Urban Design Review Panel Report

500 Coventry Road, Ottawa

**RE: Urban Design Review Panel Report
Site Plan Control Application
500 Coventry Road, Ottawa**

Enclosed, please find responses to the Urban Design Review Panel's comments provided on February 2, 2024, regarding the Site Plan Control application for the property municipally known as 500 Coventry Road, Ottawa.

Master Plan - Conceptual Option 2 (Preferred)

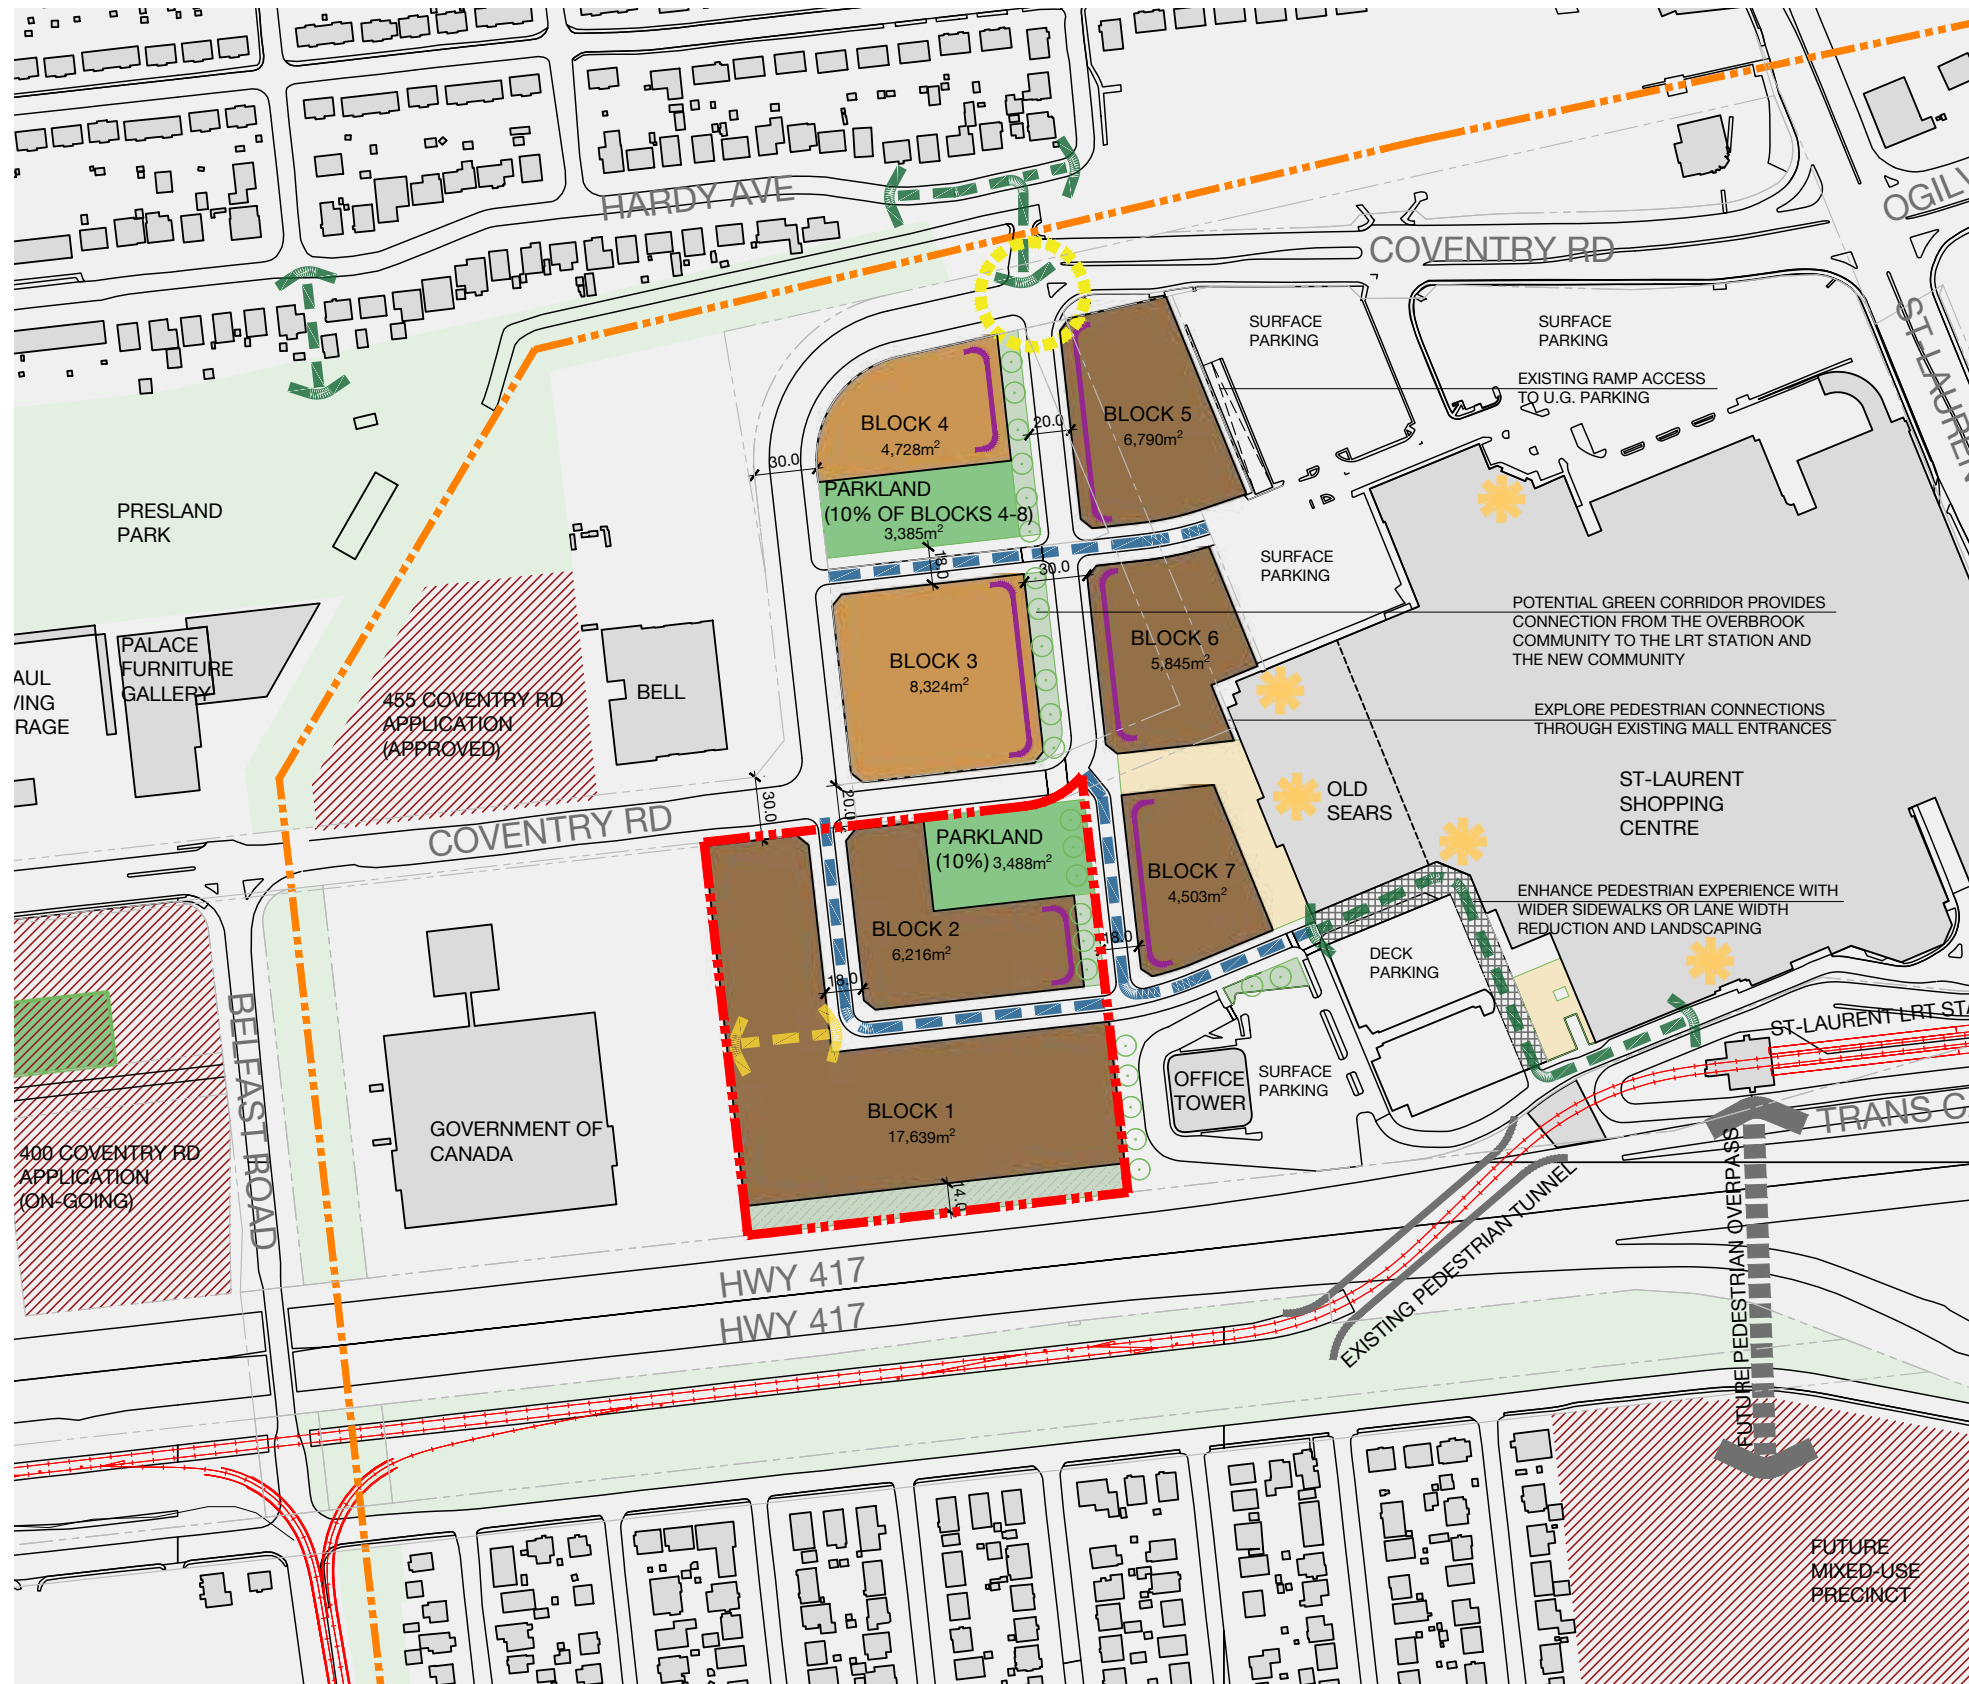
17. The Panel recommends pursuing 'Option 2' for the overall site master plan.

Response: Acknowledged.

Master Plan - PHASE 1

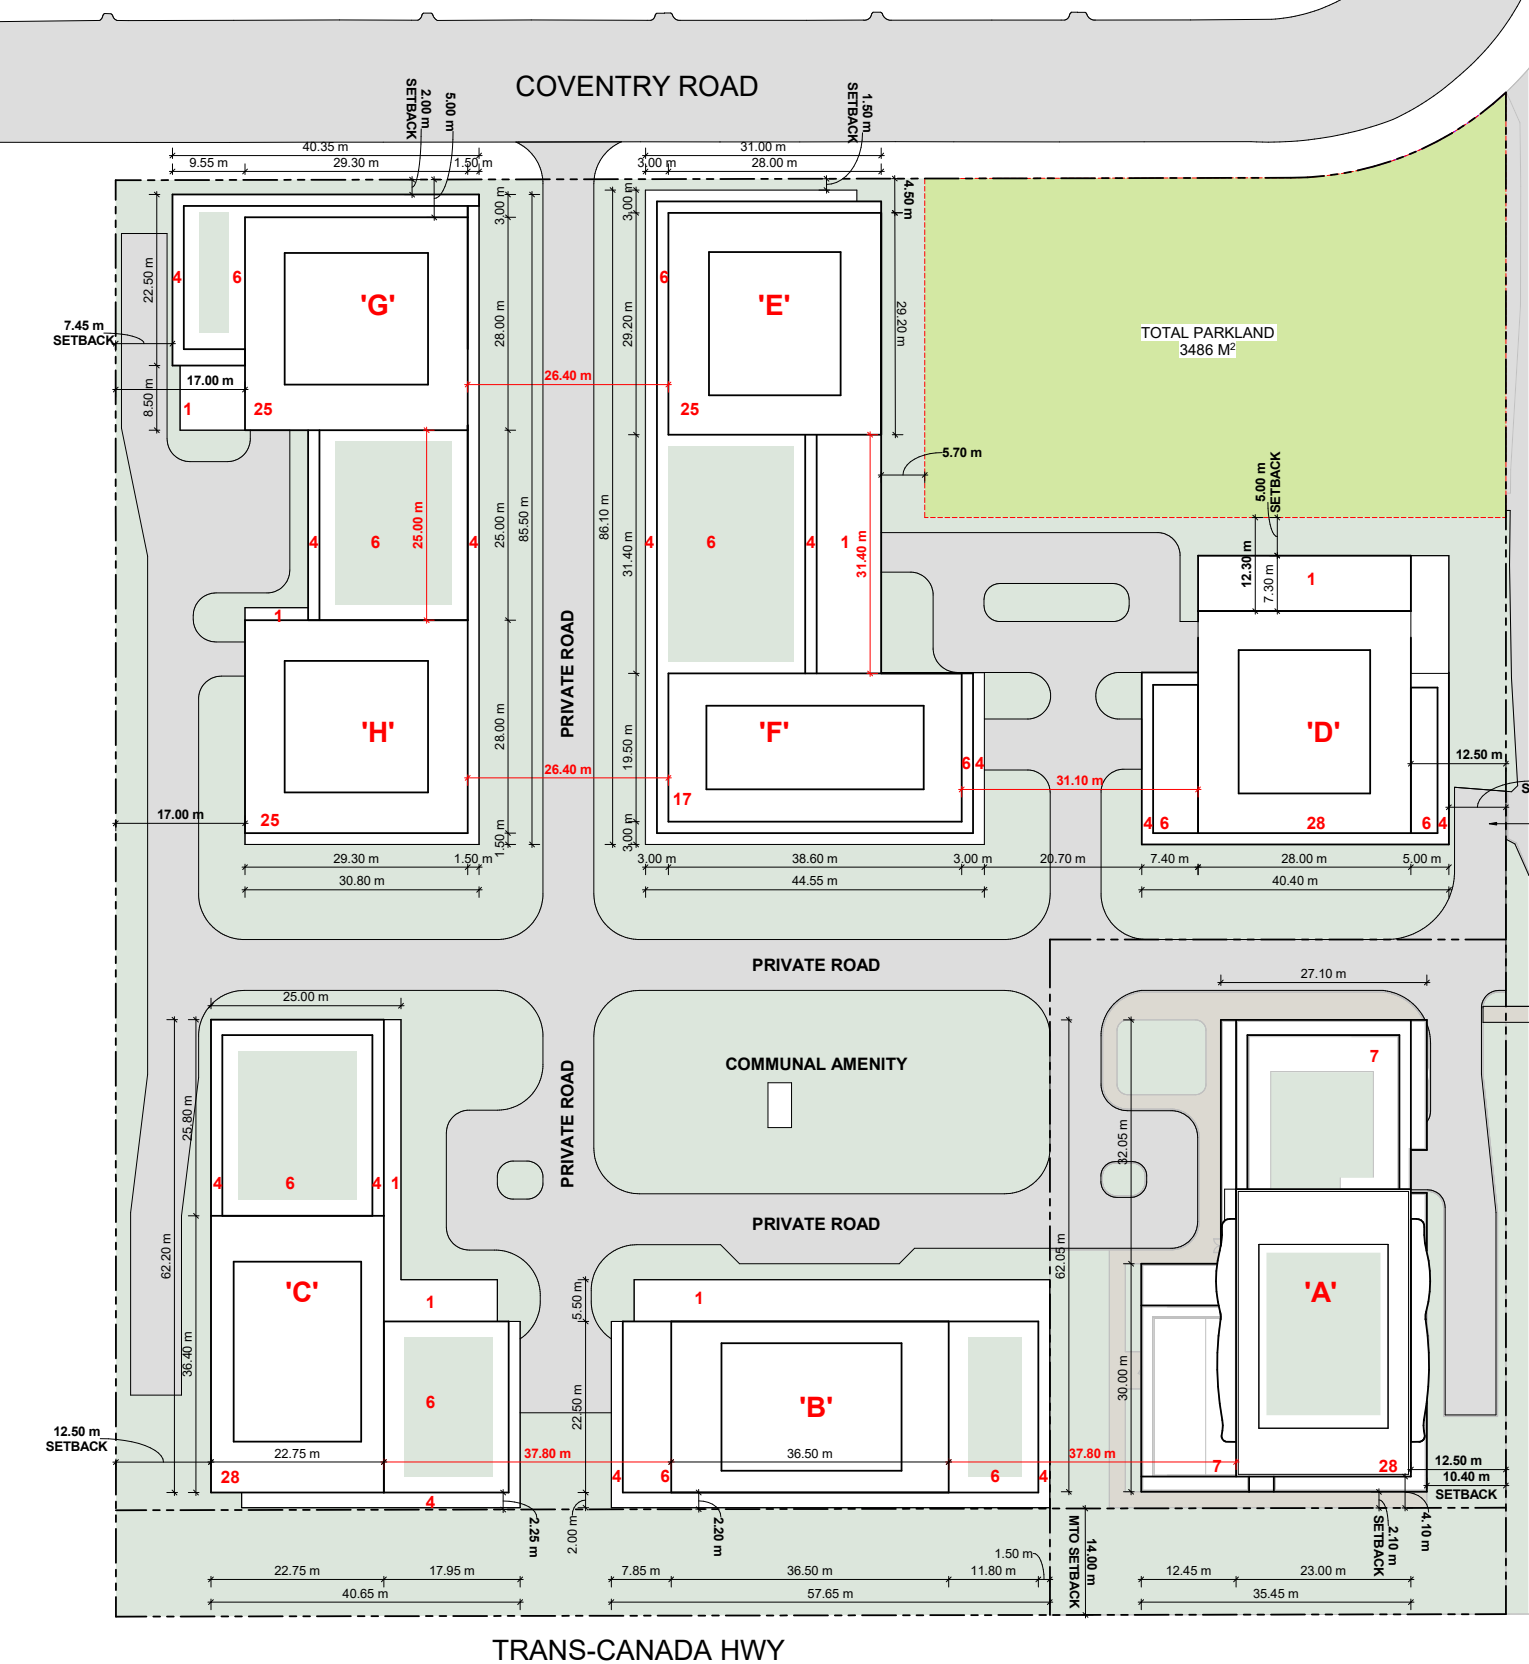
2. The Panel strongly recommends more thought be given to creating a pedestrian-first built environment and layering to the Phase 1 Master Plan presented (p.26), as it currently appears overly vehicle oriented.

18. The Panel has concerns with how vehicle oriented the Phase 1 Master Plan (p.26) appears to be, and strongly recommends the loading and drop-off areas be located closer to the two main private roads. As currently designed, the loading and drop-off areas are too deep into the sites and not optimizing land use for a pedestrian-first environment.

- Consider providing valuable pedestrian mid-block connections and linkages to the mall and park along the east and west edges of the Phase 1 Master Plan (p.26).

Response: Master plan design has been revised to be more pedestrian oriented with less paved road. Refer to sheet SPA005A.

Response: Acknowledged.

Response: Majority of ramps have been internalized. The addition of a parking ramp structure has been designed to partially cover the ramp and make it more animated, tying it into the design of the building.
